LAND EAST OF WOODSTOCK, OXFORDSHIRE: ARBORICULTURAL IMPACT ASSESSMENT ADDENDUM

1. Further to arboricultural details submitted as part of a hybrid application for residential led development at land east of Woodstock, Aspect Arboriculture have prepared the following addendum in light of proposed to changes to the scheme, these changes are listed below.
2. **Concept Masterplan (Phase 1):**

PROPOSED DEVELOPMENT
AT LAND EAST OF WOODSTOCK,

Tree Protection Plan 8854 TPP 07 (Upper Campsfield Road Access)

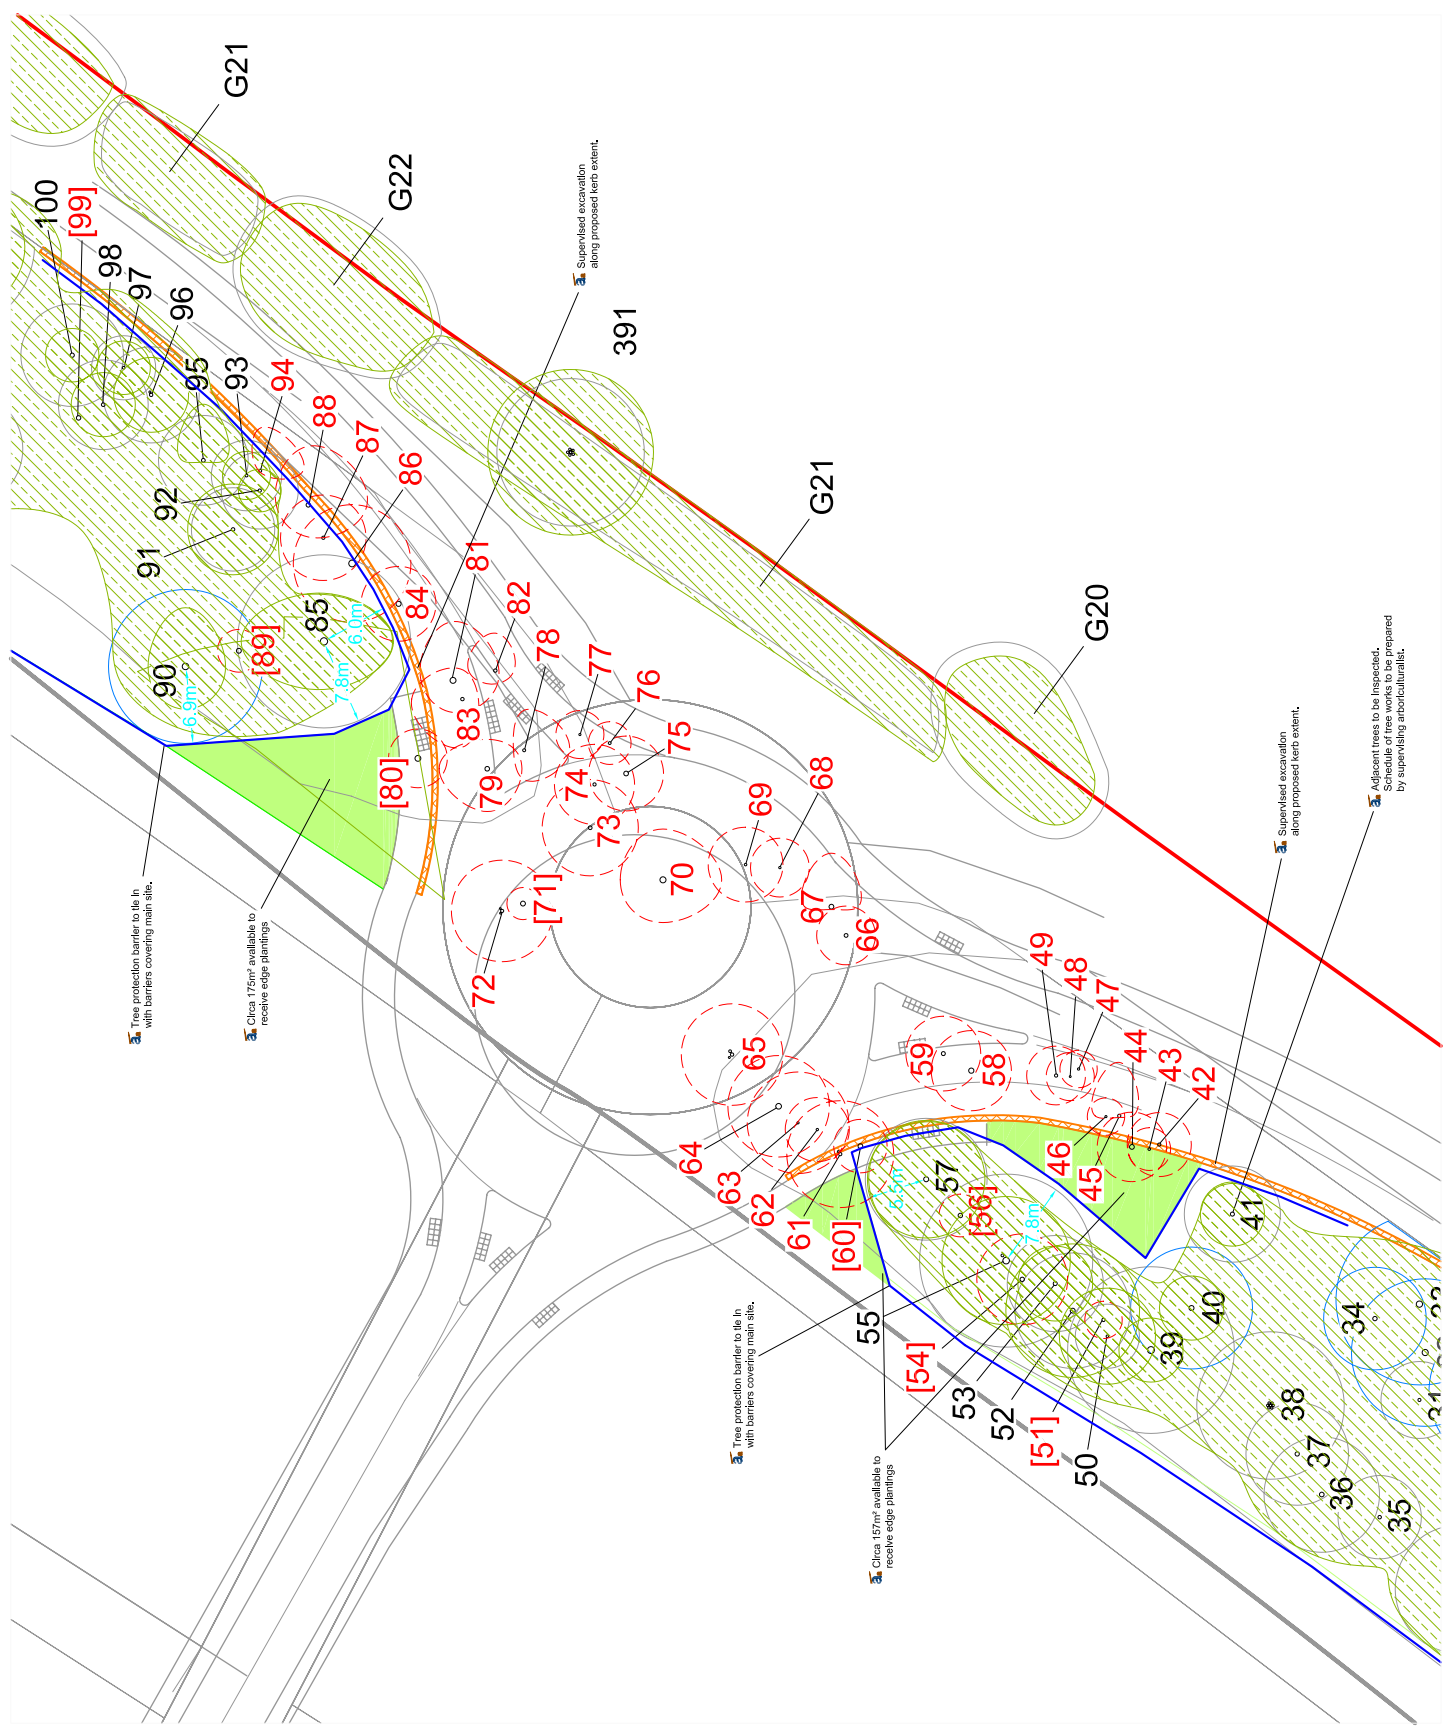
4. Relocation of proposed Upper Campsfield Road vehicular access:

The layout for the proposed Upper Campsfield Road vehicular access has been relocated approximately 70m south. This incurs the removal of 36no individual trees, 2no of which are category B (refer Table.2 overleaf). The previous layout incurred the removal of 33no individuals trees, however 6no of those were category B.

An unwooded area of c.332m² is available to the north and south of the relocated roundabout which could receive reinforcement plantings to create a new wind-firm edge adjacent to cleared areas. This area is less than that achieved with the previous layout (c.500m²); however, this is due to the presence of more existing trees that can be retained north and south of the proposed roundabout.

Mitigation planting could be further extended within the retained sections north and south of the proposed roundabout through selective thinning and replacement of category U trees. This could be included within a wider programme of management typical of woodland and shelterbelts, i.e. by condition or reserved matters application for the wider site.

The installation of kerb setts associated with the Upper Campsfield Road access should be manually excavated due to its proximity to RPAs of retained edge trees within G1. The proposed access road should also be manually excavated where occurring within the RPAs of tree nos. T33, T41, T57, T85, T92, T93 and T96. The procedure for manual excavation is detailed within the submitted AIA (refer to enclosure C, section 6.4.10 – 6.4.11).

Total trees to be removed to accommodate proposed roundabout = 36
 Category B trees to be removed = 2
 Category C trees to be removed = 34

PRELIMINARY TREE PROTECTION PLAN (UPPER CAMPSFIELD ROAD)

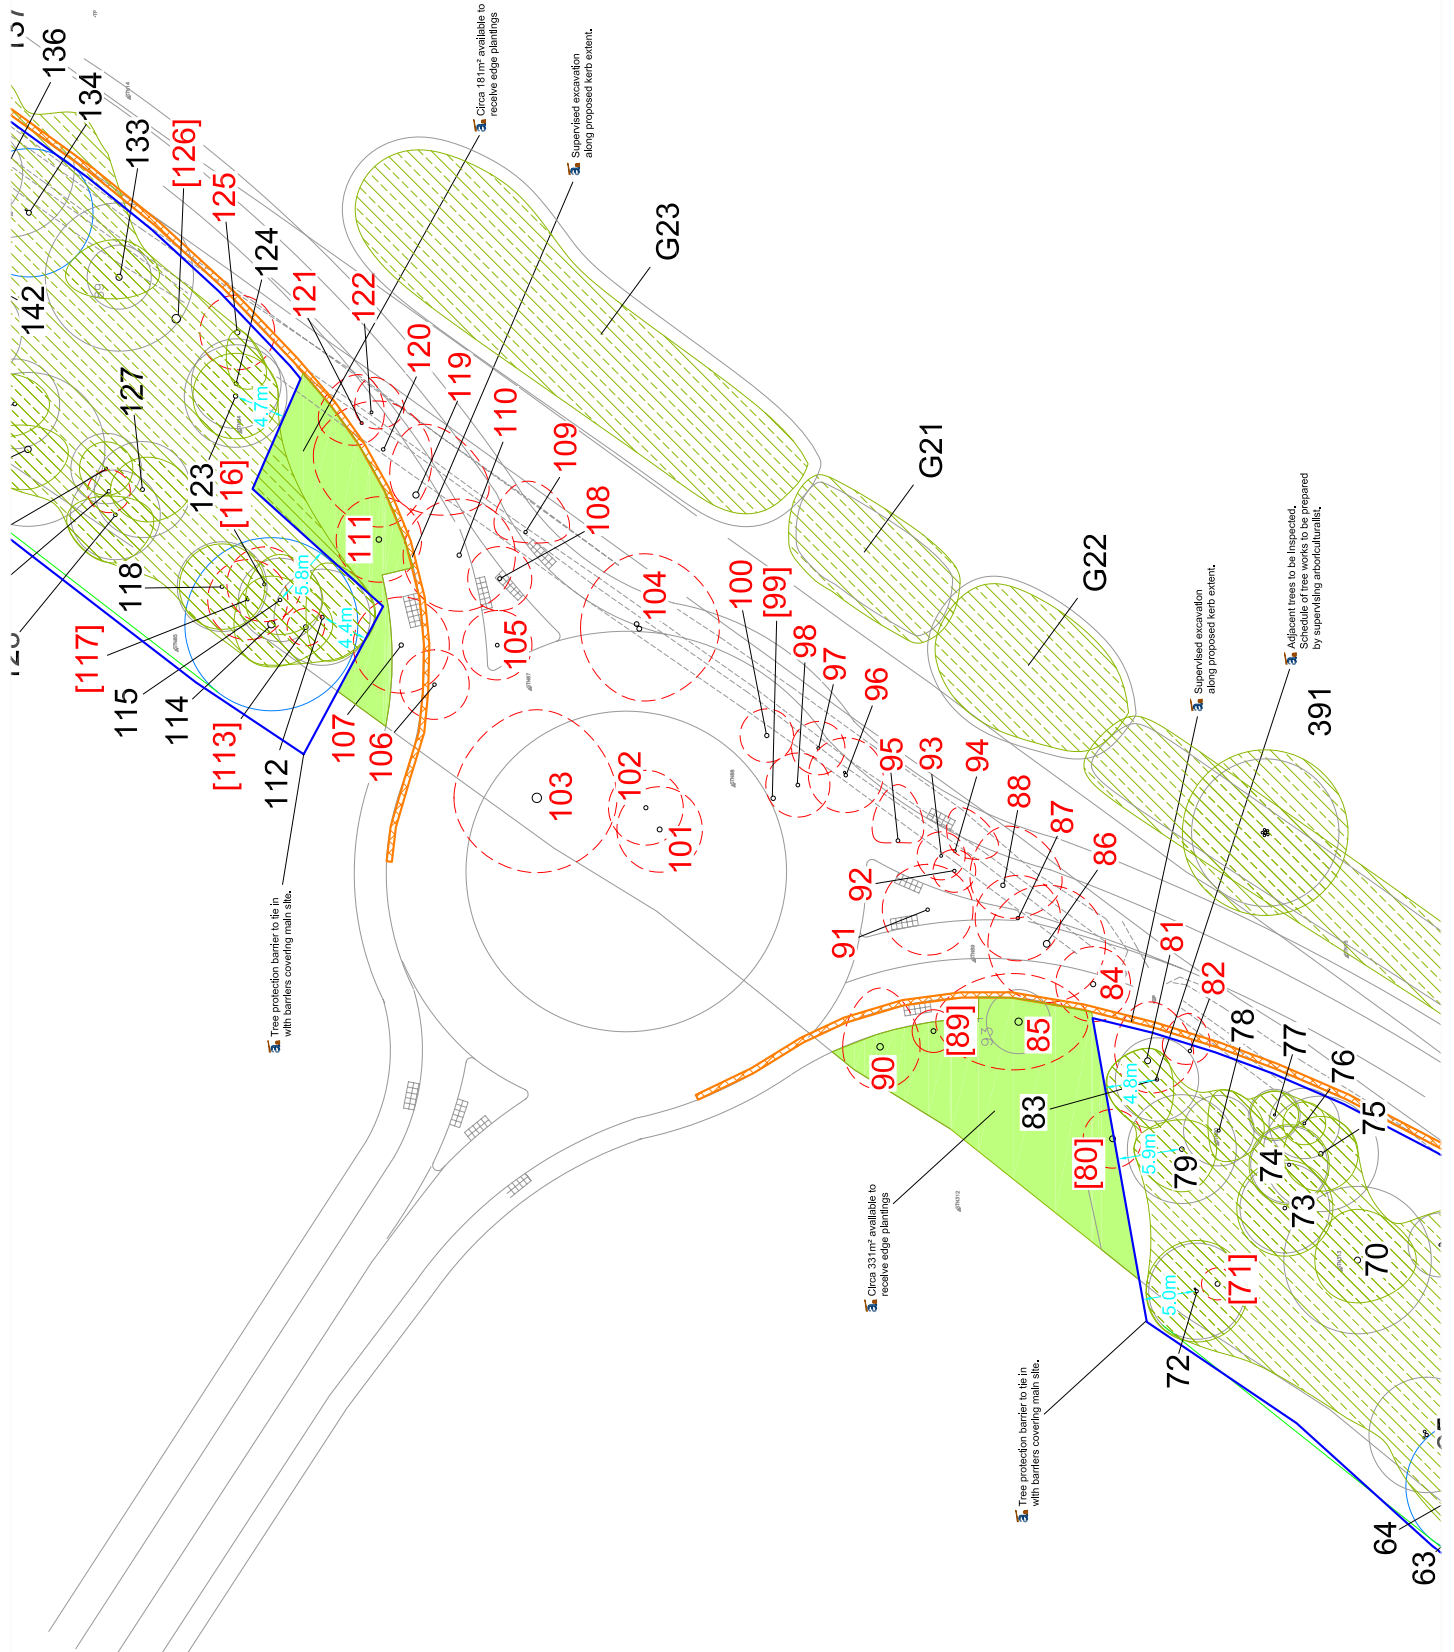
- 6.2.9 **Upper Campsfield Road Vehicular Access:** The requirement to introduce a vehicular access to the site at this location means that it is necessary to remove trees within category A group G1.

- 6.2.11 With the exception of category B trees which are established (but not essential) components of G1, the majority of the tree removals are concentrated on trees with reduced individual impact, i.e. The proposals incur the removal of 33no individual trees, 6no of which are category B (refer table.2).

- 6.2.12 Whilst the proposals will transect G1, the impact is localised to the access point through: the avoidance of additional pedestrian footways to the northbound verge, retention of existing levels tree side of the kerb and the siting of services within the carriageway footprint.

- 6.2.13 G1 demonstrates evidence of re-stocking and this should be extended to reinforcing the exposed faces to ensure a new wind-firm edge adjacent to cleared areas. An approximate area of 500m² is available to the north and south of the new roundabout
